Access Design Assessment Report

2A Gregory Place
Harris Park NSW 2150

Project: 2A Gregory Place Harris Park NSW 2150
Document Type: Access Design Assessment Report
Our Reference: P222_159-2 (ACCESS) NH

Figure 1 – Pedestrian entries

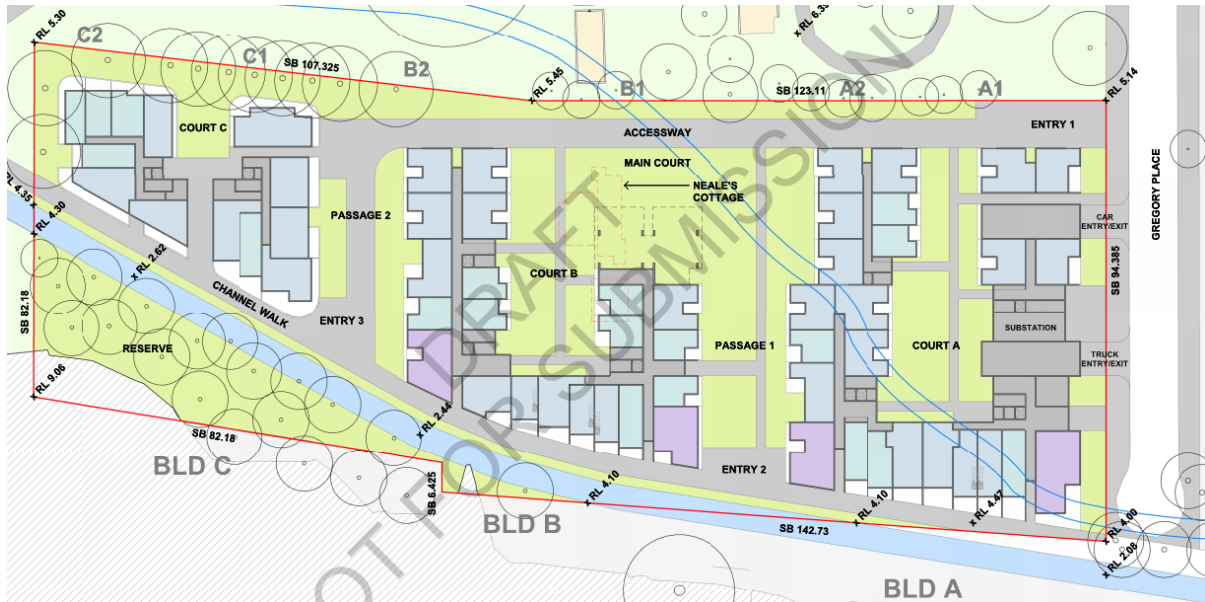
The proposed pedestrian entries to the buildings, have been highlighted in the figure below.

It is identified that accessways are provided from the main points of pedestrian entry and between building entries via pedestrian links.
